RE: CONCEPTUAL GRADING & DRAINAGE PLAN FOR UNIVERSITY VILLAGE  
SUBMITTED APRIL 4, 1988, FOR SITE DEVELOPMENT PLAN APPROVAL  
(L15/DB)

RE: REVISED CONCEPTUAL GRADING & DRAINAGE PLAN SUBMITTAL OF  
UNIVERSITY VILLAGE - RECEIVED AUGUST 29, 1986 FOR SITE  
DEVELOPMENT AGREEMENT (L-15/DB)

RE: CONCEPTUAL GRADING & DRAINAGE PLAN SUBMITTAL OF UNIVERSITY  
VILLAGE - RECEIVED JULY 28, 1986 FOR SITE DEVELOPMENT PLAN  
APPROVAL (L-15/D8)

DRAINAGE REPORT  
FOR  
UNIVERSITY VILLAGE, PHASE III  
MOBILE HOME PARK  
March 24, 1975

STREET CAPACITY

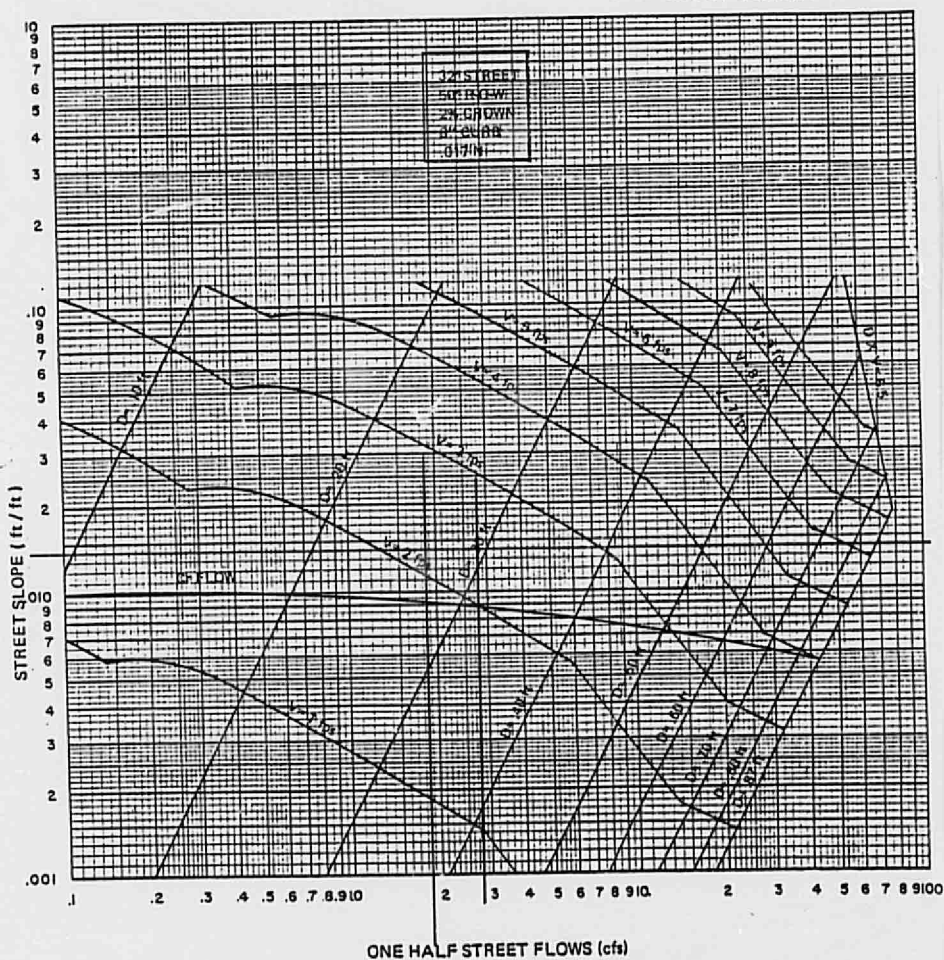
When making the street capacity calculations, please check that the depth of flow for the 10 year storm runoff does not exceed 0.5' and that the product of the depth and the velocity is less than 6.5, per the DPM.

1. Provide street capacity calculations for University Boulevard to see if ordinance criteria, requiring one free driving lane, is being met with the developed discharge from University Village.
2. Provide capacity of existing storm drain inlets in University Boulevard to direct street flows into the arroyo.

32' FF Street for  
From Plate 22.30-1  $\frac{1}{2}$  Flow = 28.2 (100)  
18.6 (10)

$$\text{@ } \frac{1}{2} Q_{10} = \overset{18.6}{\cancel{28.2}} \text{ cfs}, v \approx 2.1 \text{ fps}$$

$$d \approx 0.26 \text{ ft}$$

$$\text{@ } \frac{1}{2} Q_{100} = 28.2 \text{ cfs}, v \approx 2.4 \text{ fps}$$

$$d \approx 0.3 \text{ ft.}$$

$$v_{10} \times d_{10} = 2.1 (0.26) = 0.55' \ll 6.5'$$
